Ingress and egress delay impact on 802.1AS clause 13 (preso-V.3)

Frank Effenberger
Huawei Technologies

MPCP and reference planes

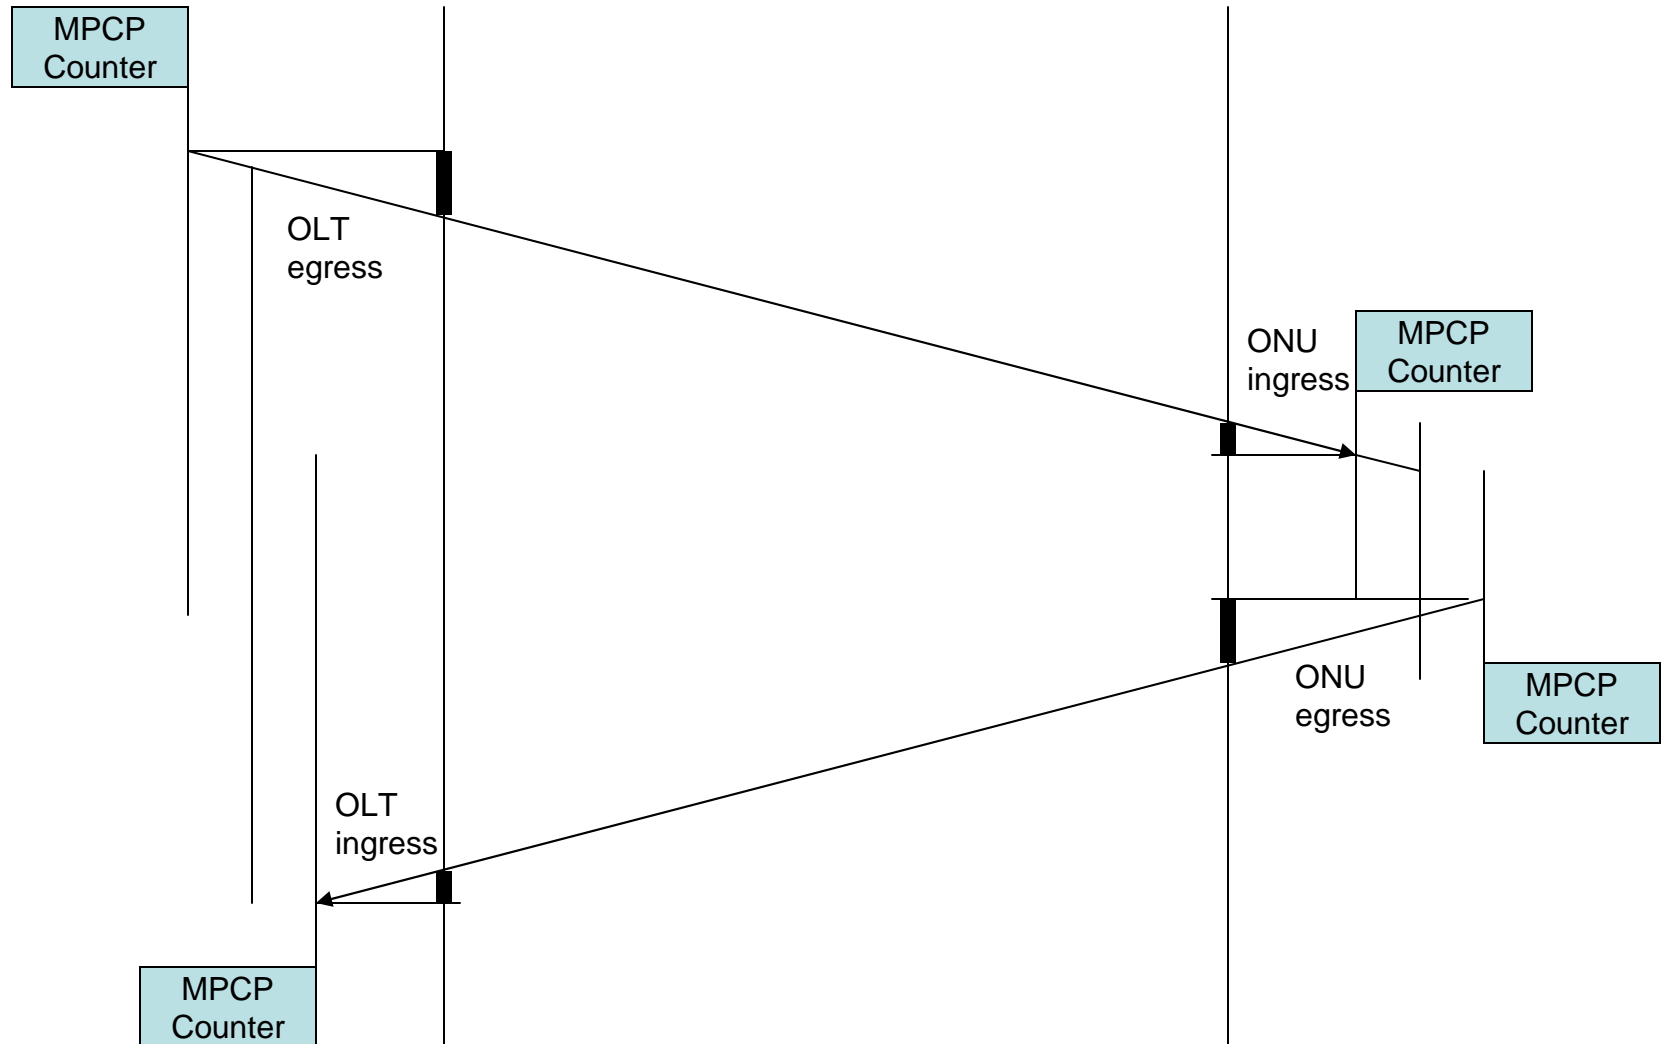
- Eq(13-1) in 802.1AS 7.0:
 - $ToDx,i = ToDx,o + RTT * K / RateRatio$
 - Assume $K = IndexFactor = Nup / (Ndown + Nup)$
- As noted in another comment, we should multiply by the RateRatio, not divide. So, the repaired eq. is:
 - $ToDx,i = ToDx,o + RTT * K * RateRatio$
- RTT measured in EPON
 - $RTT = OLTegress + downchannel + ONUingress + ONUegress + upchannel + OLTingress$
 - I.e, $RTT = (OLTegress + OLTingress) + (downchannel + upchannel) + (ONUingress + ONUegress)$
- Note: the egress and ingress latencies are measured in the local clock timebase

- The ideal calculation of $ToDx,i$
 - If $ToDx,i^*$ is the time when the ONU MPCP counter equals X , and
 - $ToDx,o^*$ is the time when the OLT MPCP counter equals X ,
 - Then: $ToDx,i^* = ToDx,o^* + [OLTegress + (downchannel + upchannel) \cdot K + ONUingress] \cdot RateRatio$ Eq. (1)
- The calculation in Eq.(13-1)
 - $ToDx,i = ToDx,o + [(OLTegress + OLTingress) + (downchannel + upchannel) + (ONUingress + ONUegress)] \cdot K$
- These two don't match quite right...

- If we define:
 - $ToDx,i = ToDx,i^* - [ONUingress - K \cdot (ONUingress + ONUegress)] \cdot RR$
 - $ToDx,o = ToDx,o^* + [OLTegress - K \cdot (OLTingress + OLTegress)] \cdot RR$
- Then we can say
- $ToDx,i = ToDx,o + RTT \cdot K \cdot RateRatio$
 - This is what we want for equation 13-1
- The key definitions:
- $ToDx,i$ is the time when the MPCP counter at clock slave i equals X minus the ONUlatencyfactor.
